DOCUMENT 009113 – ADDENDUM NO. 2

- A. Project Name: Optimist Pool Bathhouse Repair
- B. Owner: City of Raleigh, Recreation and Cultural Resources/Design Development Division
- C. Architect: Osterlund Architects, PLLC.
- D. Architect Project Number: 2325.
- E. Date of Addendum: 3-1-2024.

Optimist Pool Bathhouse Repair

SEALS:

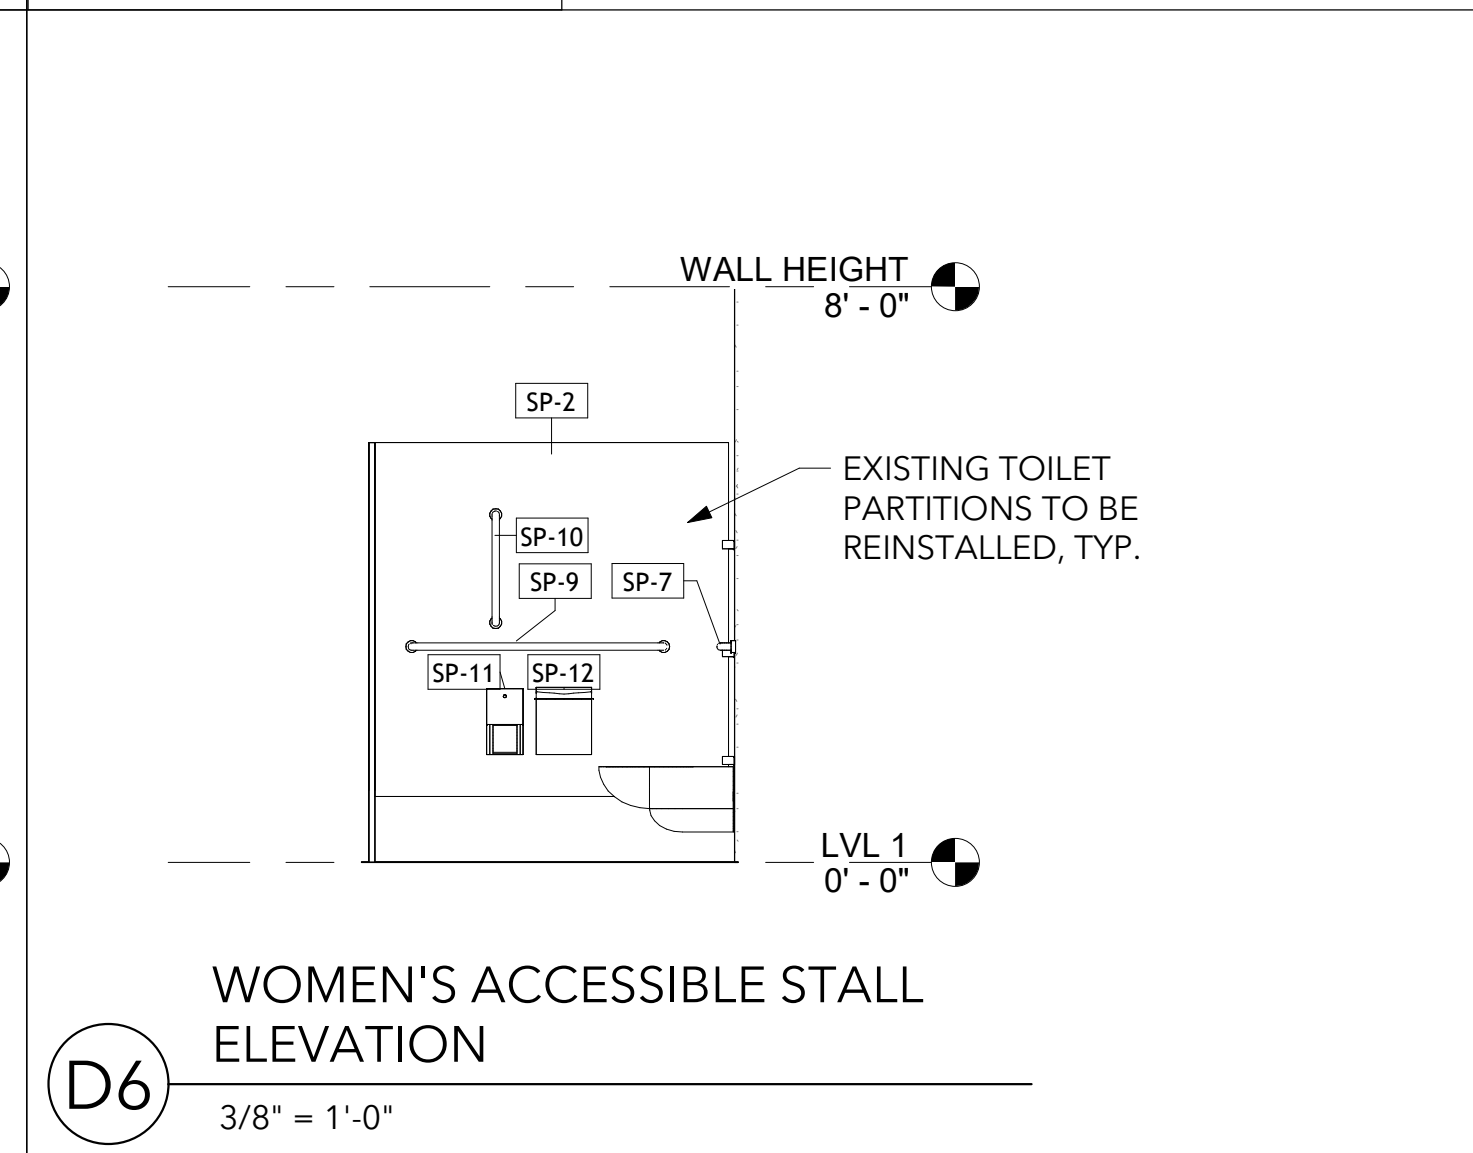
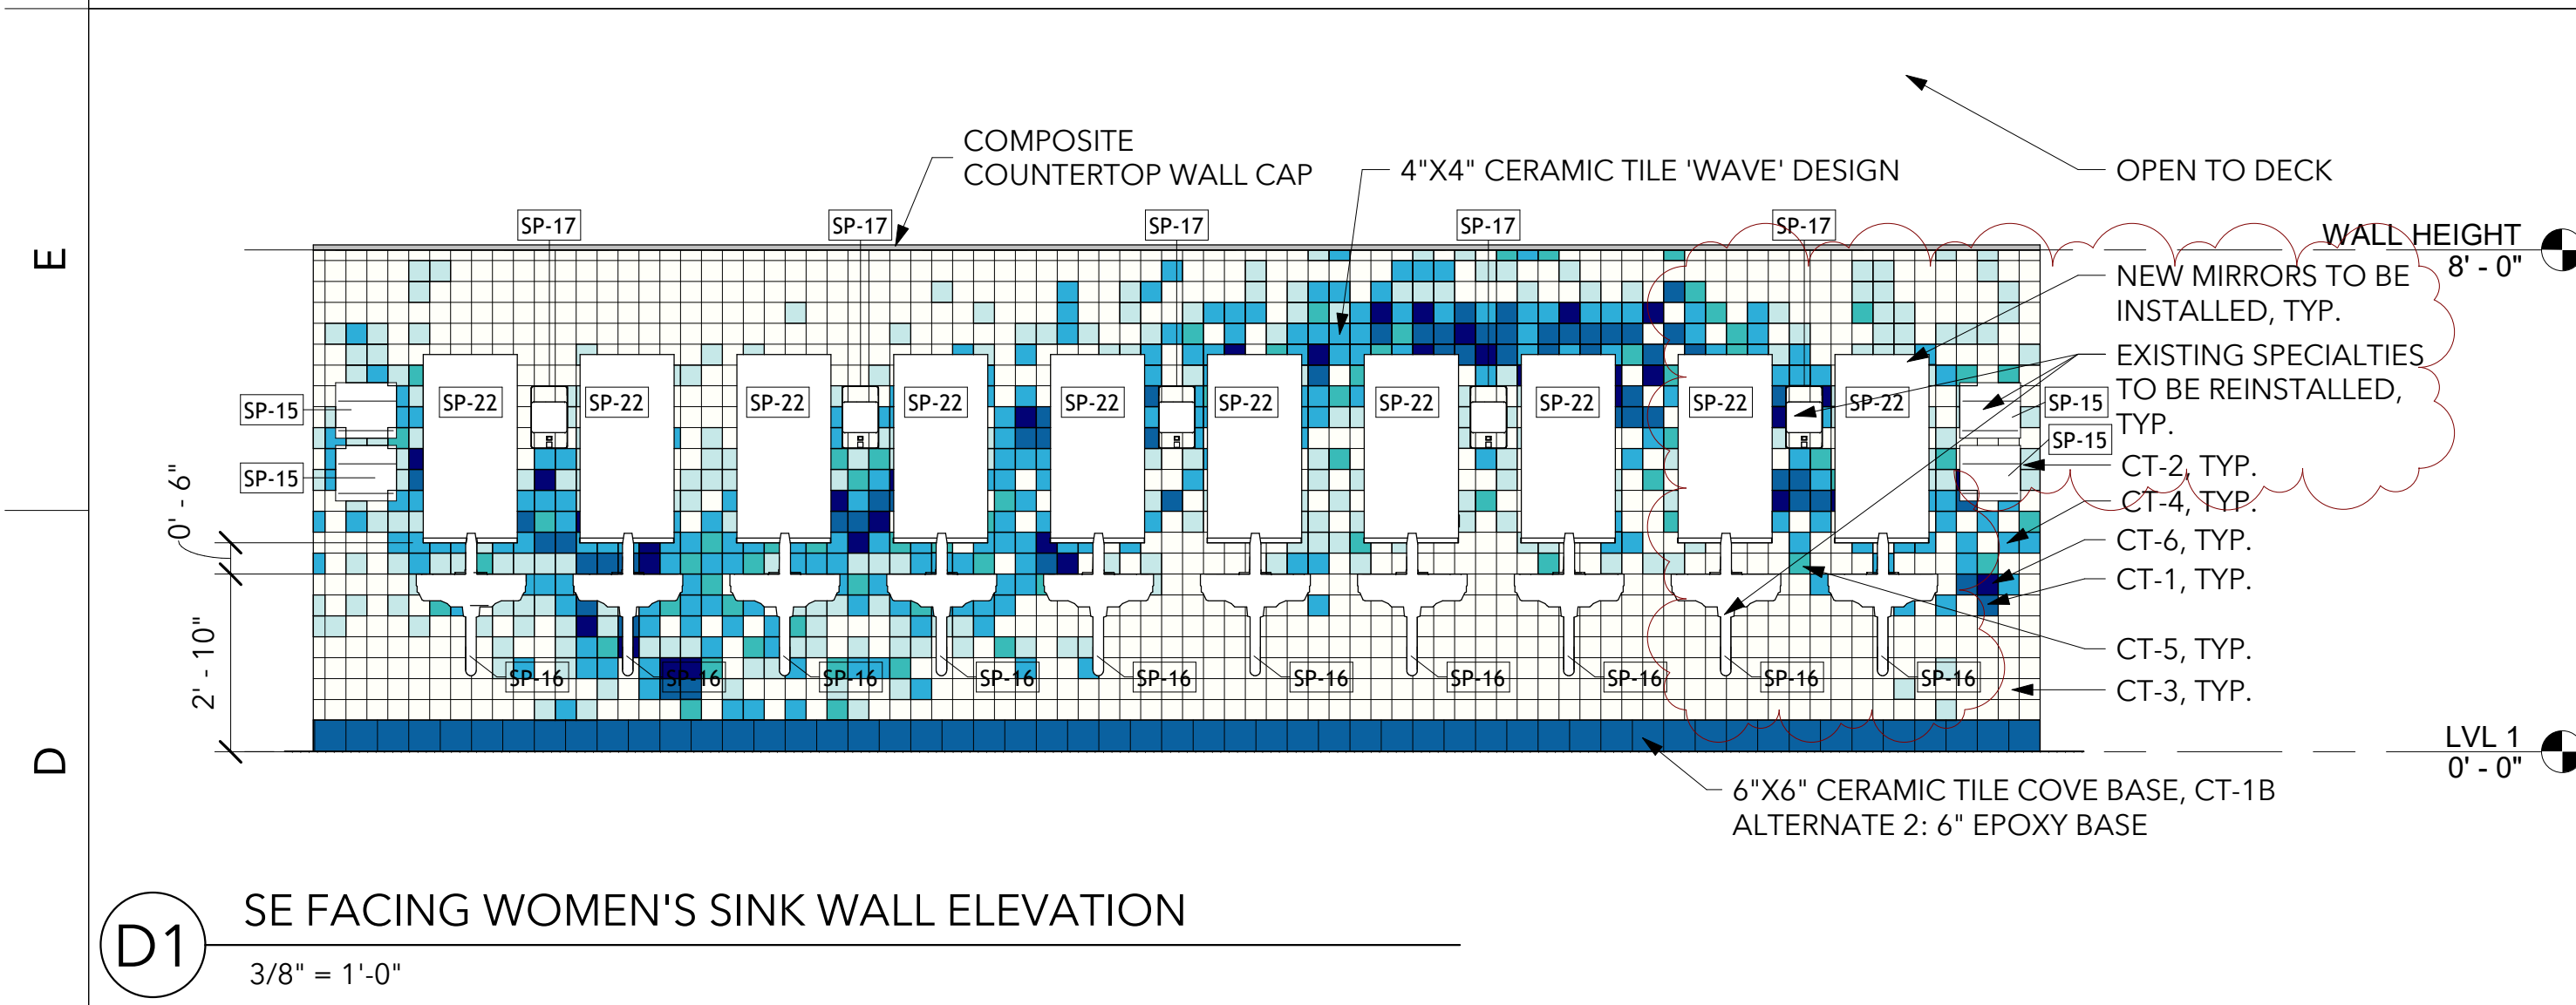
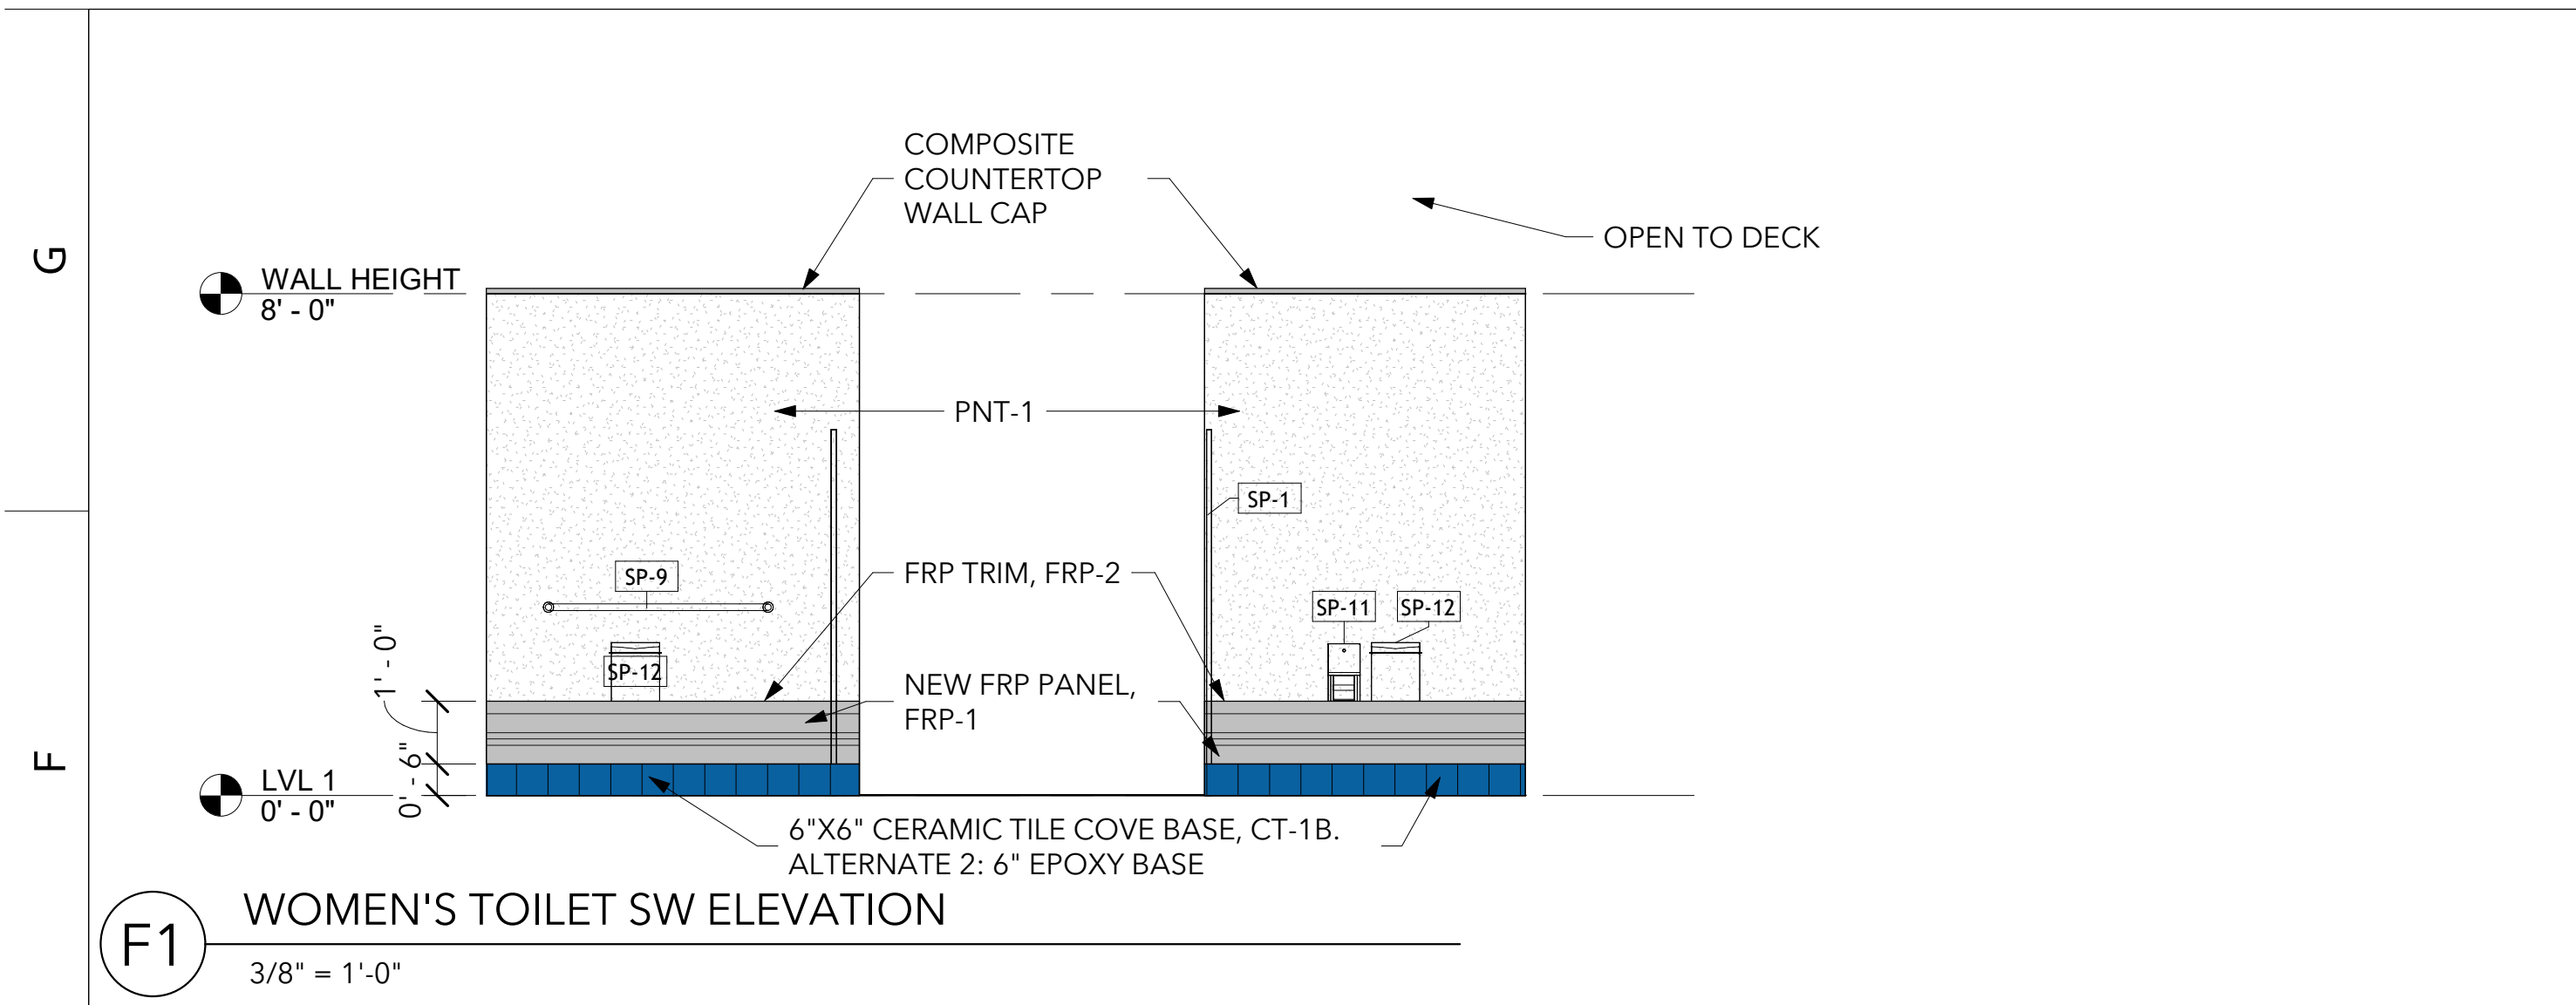
- A. This Addendum includes the following attached Documents and Specification Sections:
 - 1. Document 2325 Planholder List, dated 2-27-2024. (new)
 - 2. Document 2325 Bidder RFI Log, Dated 3-1-2024. (new)
 - 3. Document 2325 08 R2 I Sheets 03.01.24. (revised)
 - a. Revised Drawing D1-I201 to include all new mirrors instead of salvage and reinstall.
 - b. Revised Drawing A5- I204 to include all new mirrors instead of salvage and

RFI No.	Date Received	Via	Description	Response	Response Date	Addendum No.
1	2/19/2024	Email	I201 detail D1 and I 204 Detail A5 both have a note showing existing to be reinstalled pointing to SP-22 (mirrors)	Mirrors are all to be new, purchased and installed by GC.	2/22/2024	2
2	2/19/2024	Email	I 601 shows SP-22 Mirrors as new and by GC.	Mirrors are all to be new, purchased and installed by GC.	2/22/2024	2
3	2/19/2024	Email	Are mirrors to be removed and reinstalled per elevation or new per schedule?	Mirrors are all to be new, purchased and installed by GC.	2/22/2024	2
4	2/21/2024	Pre-Bid Meeting	Are Bid Bonds or P&P Bonds Required?	Bid Bond is required over \$500,000; P&P is required over \$300,000	2/21/2024	2
5	2/21/2024	Pre-Bid Meeting	Will Conex be required during construction?	Yes, Conex will be required. Hallway will be available for storage but only after June 13, 2024	2/21/2024	2
6	2/21/2024	Pre-Bid Meeting	What is the age of the building? Is asbestos a concern?	Building was built in 2008, no hazmat required.	2/21/2024	2
